ASB-1018

## Service Bulletin

**Subject:** TS-950 14.200 MHz Transmit Spur  
14, 1993

**Date:** May

### AF Unit (X49-3020-00) Component Side View

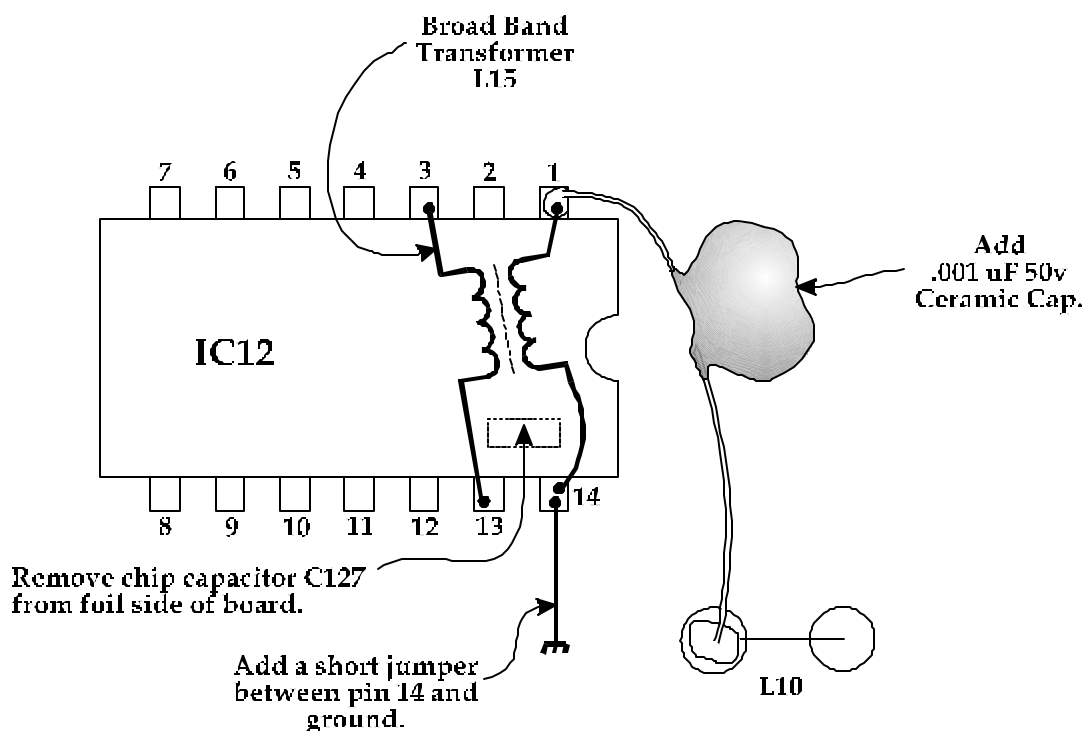
A close-in transmit spur might be present on early model TS-950(S) (Serial Number 1010XXX and below) transceivers when operating at a dial frequency of approximately 14.200.0 MHz. This spur is seen approximately -40 to -50 db down from the fundamental.

The output from the mixer (IC12) which generates the final PLL loop comparison frequency for the AF unit contains harmonic radiation at approximately 36 to 68 MHz.

Qty	Description	Kenwood Part No.	Circuit Description
1	Broad band transformer	L19-0346-05	L15
1	.001 uF 50v capacitor	CK45B1H103K	C127

1. Solder the primary of the transformer to pins 3 and 13 of IC12. You will have to bend the terminals slightly.
2. Solder the secondary of the transformer to pin 1 and 14 of IC12.
3. Remove chip capacitor C127 from the foil side of the board.
4. Connect pin 14 of IC12 to the ground pattern.
5. Add the new C127 from pin 1 of IC12 to L10 as shown in the accompanying illustration.
